# Origination Form

## Proposed Revisions to a Standard Plans Index

<b>Originator:</b>	Turley, Joshua	<b>Index Number:</b>	649-020
<b>Date:</b>	4/17/2024	<b>Sheet Number(s):</b>	3 and 4
<b>E-mail:</b>	Joshua.Turley@dot.state.fl.us	<b>Index Title:</b>	STEEL CCTV POLE

SECTION A-A

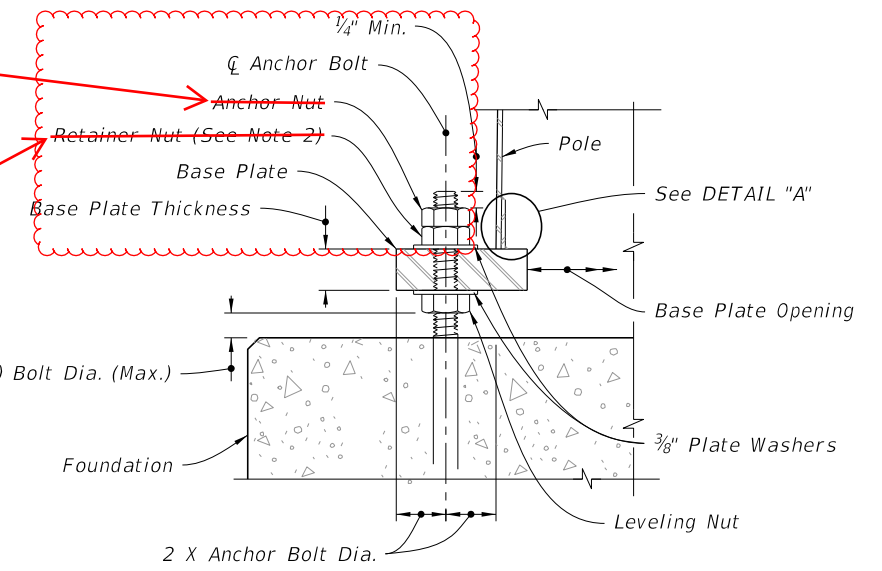
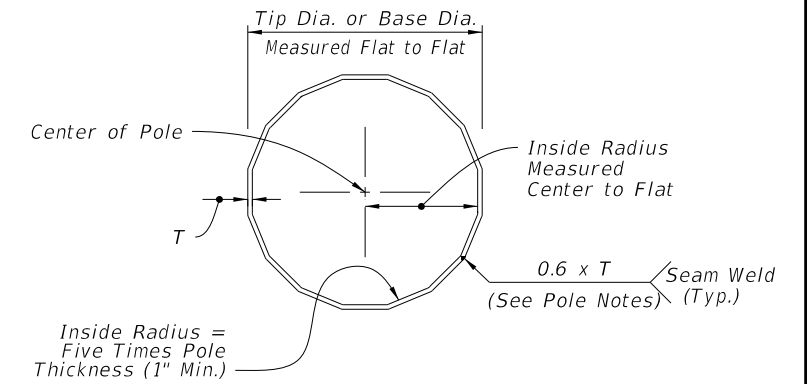
Sheet 3: Section A-A -- Corrected the label order of the anchor bolt nuts; SECTION B-B -- Modified wall thickness from text to symbol. DETAIL A -- Removed weld hatches and modified weld symbol. Removed "Pole Wall Thickness + 7/16" dimension from Joint Weld Detail. Added welding callout to Joint Weld Detail.  
 Sheet 4: FRAME DETAIL -- Modified weld detailing and modified title; SECTION C-C -- Modified weld detailing; Updated callouts and added dimensions to Rod and Eye Bolt Options.

REVISED: Retainer Nut (See Note 2)

REVISED: Anchor Nut

Sheet 3: Anchor nut labels were adjusted to correspond correctly with upcoming associated Spec change being drafted for Section 649; We corrected weld detailing for clarity and brevity.  
 Sheet 4: We corrected weld detailing to conform with accepted convention.

SECTION B-B

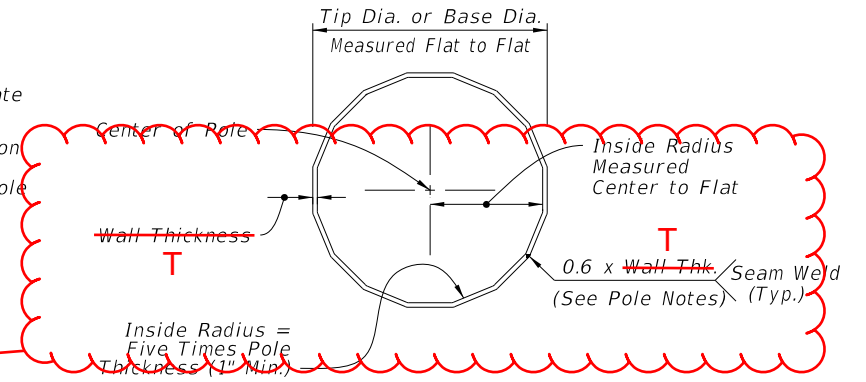
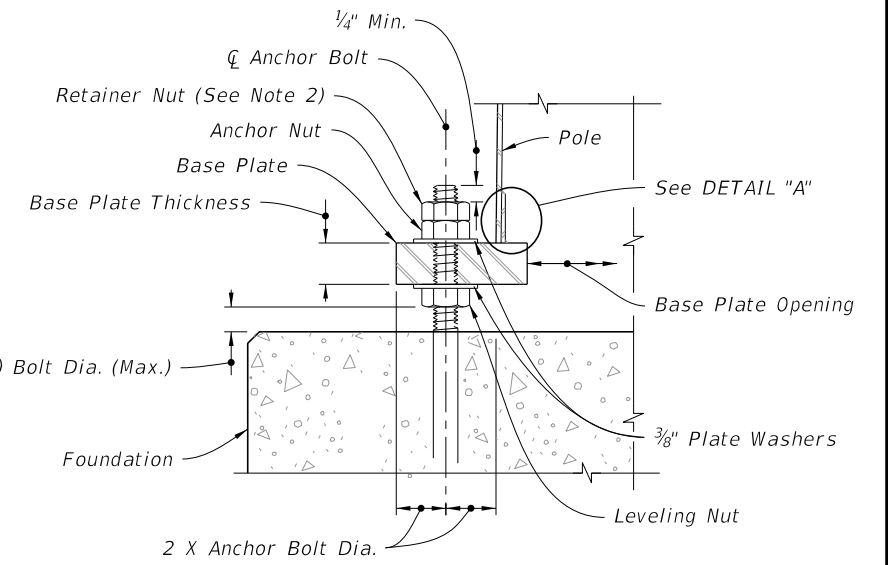
UPDATED Callouts

SECTION C-C

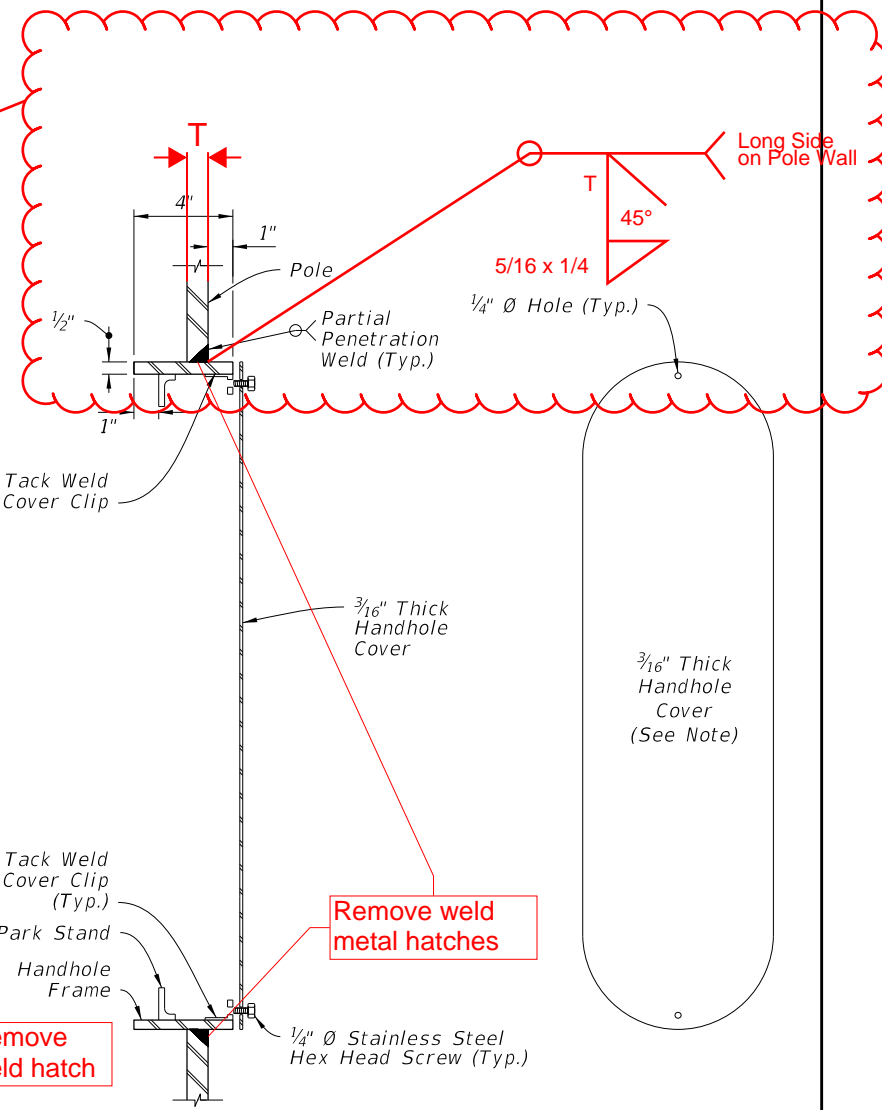
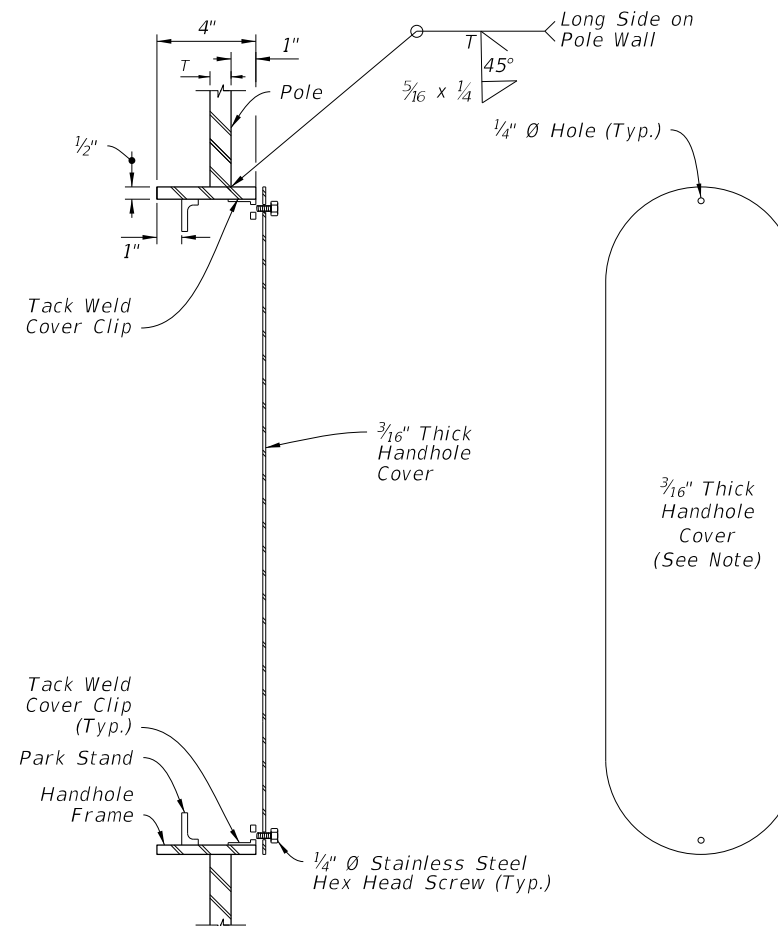
UPDATED Weld Callout and ADDED Dimension
